FACIL: 50-269 Oconee Nuclear Station, Unit 1, Duke Power Co.      05000269

SUBJECT: Submits response to NRC questions on proposed mod to plant emergency electrical sys.

Subject: Oconee Nuclear Station  
Docket Nos. 50-269, -270, -287  
Response to NRC questions on Technical  
Specification 4.6 Revision

ATTACHMENT 4-1

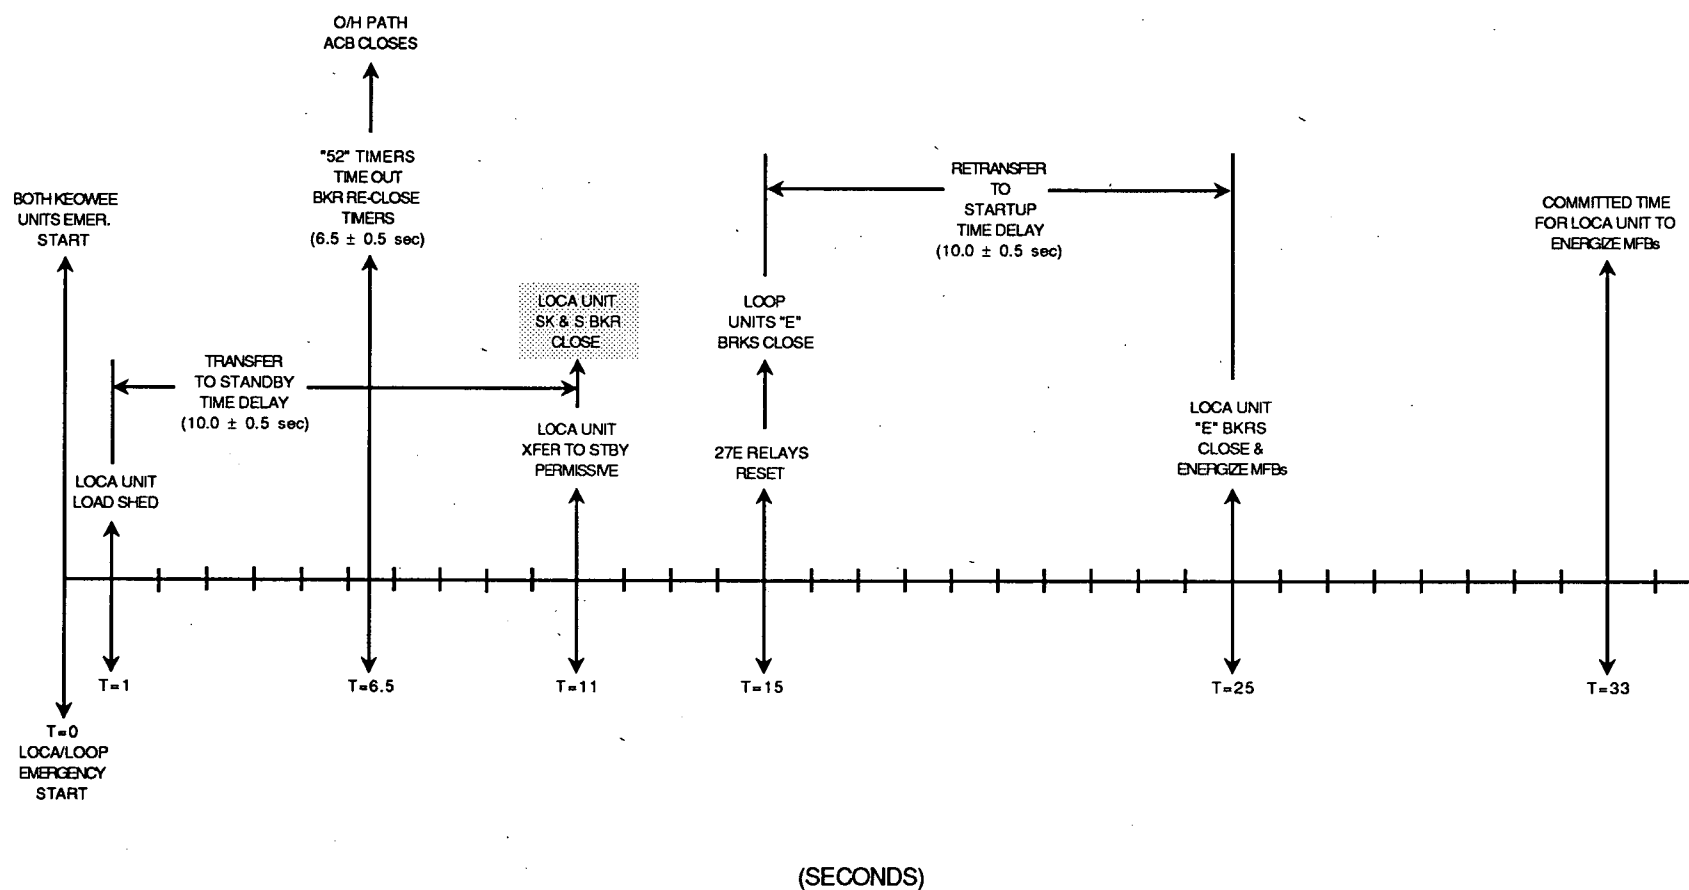
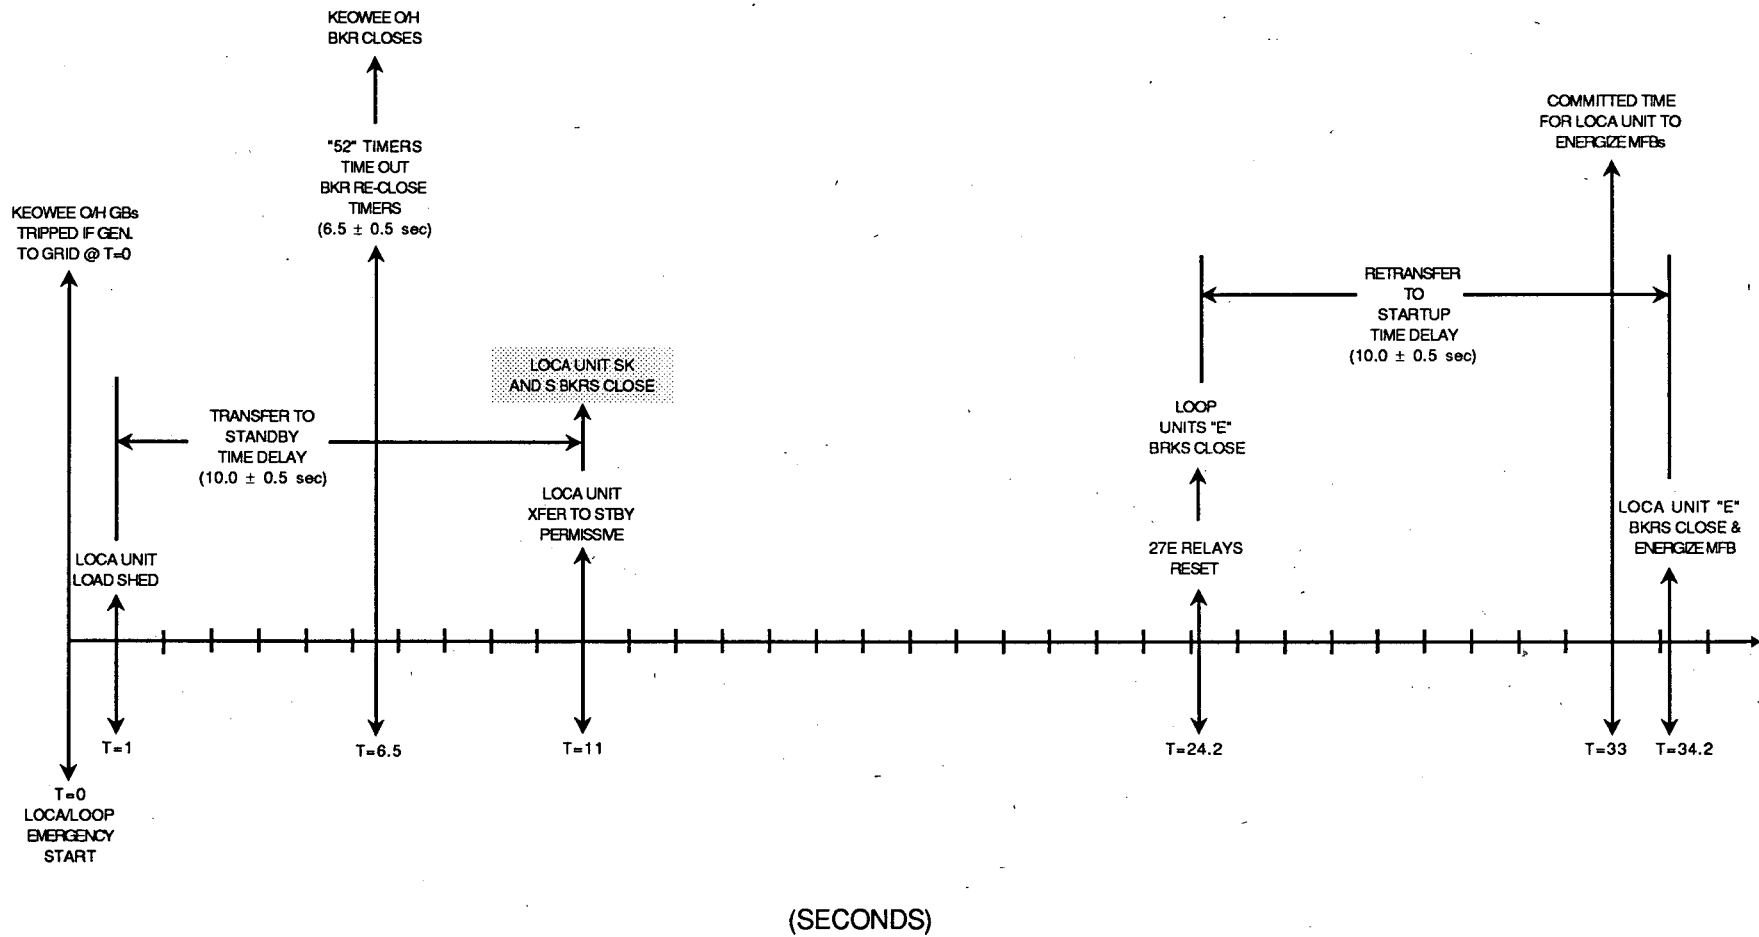
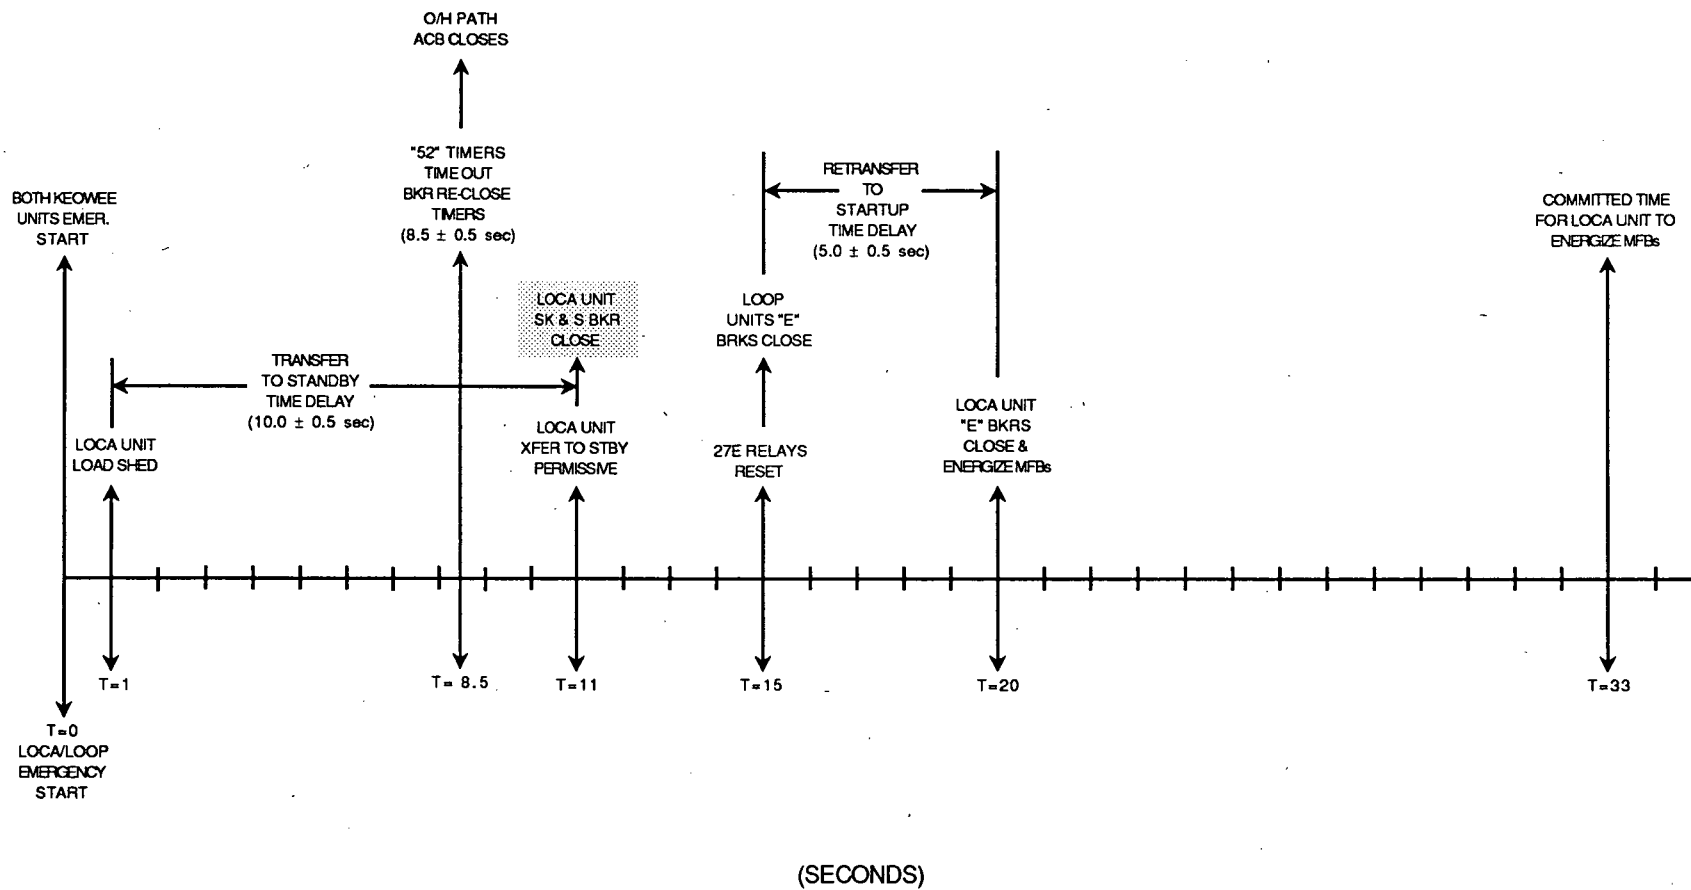
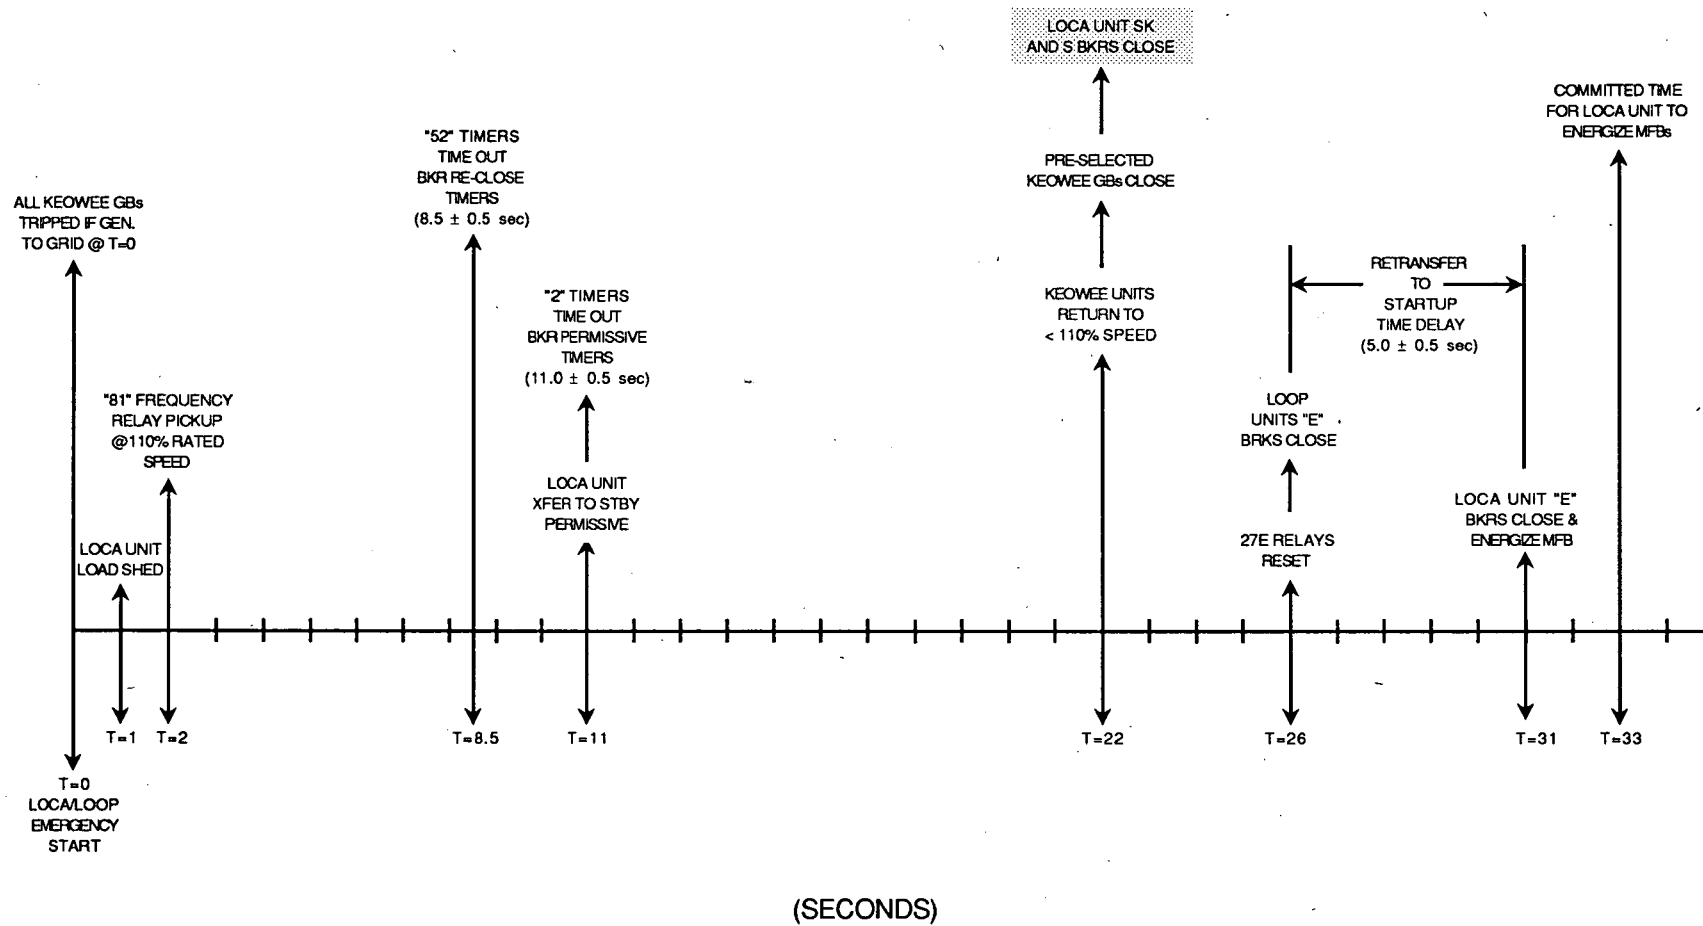
LER 93-01 references FSAR Section 15.14.3.3.6 as containing the requirements that ECCS flow be established within 48 seconds for the LOCA/LOOP scenario. Please provide a detailed discussion (using detailed timelines) of the sequence of events for worse case load rejection/overfrequency scenario which includes the worst case values (considering uncertainties) for undervoltage relay reset, frequency relay setpoints (pickup and reset) and associated time delays, breaker closure times, retransfer startup time delays, etc. Compare this to the worst case sequence for a non-overfrequency scenario to provide the basis for margin between the current FSAR analyses and a worse case load rejection scenario. Discuss any modifications and/or administrative controls that have been or will be implemented that ensure the analysis of FSAR Section 15.14.3.3.6 remains bounding.

The 48 second requirement that is listed in FSAR Section 15.14.3.3.6 can be described in two separate steps. The first part is the Keowee/EPSL time and the second part is the MOV stroke time. FSAR Section 6 describes the MOV stroke time as being 15 seconds. This 15 second allowance also bounds the start times for the Engineered Safeguards pumps. Thus, the Keowee/EPSL function must be performed within 33 seconds. Attachments 4-1, 4-2, 4-3 and 4-4 show the timelines for non-load rejection and load rejection scenarios. Tolerances are included in these figures to quantify the worst case response time. Also, these timelines indicate the pre-modification and post modification configurations.

As evident by the timelines, following the installation of the proposed modification, Keowee will be in compliance with its design basis.
